Product Change Notification - SYST-02IJUE127

ERRATA - PIC32MK Motor Control and General Purpose Errata and Data Sheet Clarification

PIC32MK General Purpose and Motor Control (GP/MC) Silicon Errata and Data Sheet Clarification

FIGURE 1: Posc CRYSTAL CIRCUIT

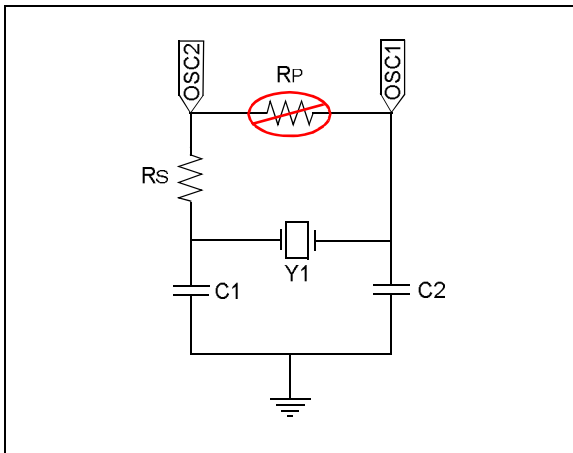
The Posc supports only specific crystal operation, as provided in [Table 1](#).

The Primary Oscillator (Posc) has been characterized to operate at 8 MHz and 12 MHz when the circuit shown in [Figure 1](#) is implemented and the operating conditions provided in [Table 1](#) are met.

TABLE 1: CRYSTAL SPECIFICATIONS

Crystal Frequency (see Note 1)	Series Resistor Rs	Posc Gain Setting POSCGAIN<1:0> (DEVCFG0<20:19>)	Posc Boost Setting POSCBOOST (DEVCFG0<21>)
8 MHz	2 kΩ	'0b00 (GAIN_0)	'0b1
12 MHz	1 kΩ	'0b00 (GAIN_0)	'0b1
24 MHz ⁽³⁾	0	'0b00 (GAIN_0)	'0b1

FIGURE 2: RESET SUPERVISOR CIRCUIT

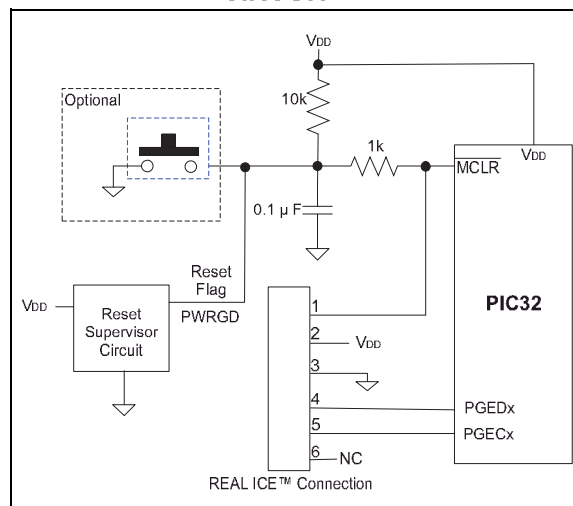
On a BOR event, $V_{POR} < V_{DD} < V_{BOR}$, a Reset is not generated when the BOR threshold is reached. System clocks will stop with all I/O pins functions frozen in their present state until either V_{DD} falls to V_{POR} or V_{DD} returns to above V_{BOR} . The user must assess if this V_{DD} brown-out condition and the resulting frozen I/O pin state has an adverse effect on their application (UART, PWM, I/O, OC, etc.).

Use an external Reset supervisor/monitor (see Figure 2). Some LDO regulators, as listed in Table 4, have an embedded reset supervisor included. The required minimum reset trip voltage of the supervisor should be at least ($V_{BOR} + 0.5V$) with the SMCLR bit (DEVCFG0<15>) = 0 and the BORSEL bit (DEVCFG2<29>) = 1 in the Configuration Words. This means that the minimum V_{DD} operating voltage of the application needs to be above the reset supervisor maximum trip voltage at [Reset Trip (max) + 0.2V], (i.e. Application $V_{DD(MIN)} = \sim(V_{BOR} + 0.5V + 0.2V)$). The reset supervisor should have an open drain output so as not to interfere with the MPLAB

programming/debug tools. This workaround assures that MCLR will generate an internal POR and reset the I/O pins before the V_{BOR} trip point.
